Sakura Dyeing & Garments Ltd. (Extension)

Kutubail, Fatullah, Narayanganj

16 March 2025

Observation-1: Mismatches in as-built drawings (New Warehouse Building).

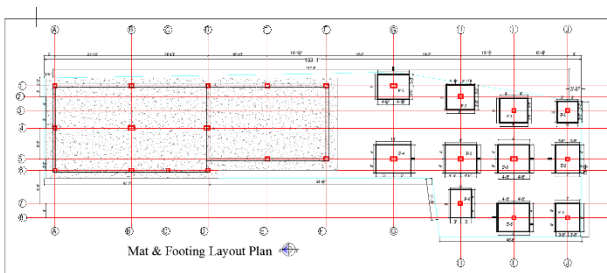
Description: Size of C1 column on grid 6-C was found 250x250 mm instead of 300x300 mm and number of rebars were found less than the drawing. Also, the beam layout at South did not fully match onsite conditions. The building engineer is required to survey the whole structure and prepare accurate as-built drawings for the structure.

Item No	Observation	Action Plan	Timeline
1.	Mismatches in as-built drawings (New Warehouse Building).	The building engineer is required to survey the whole structure and prepare accurate as-built drawings for the structure.	within 6 weeks
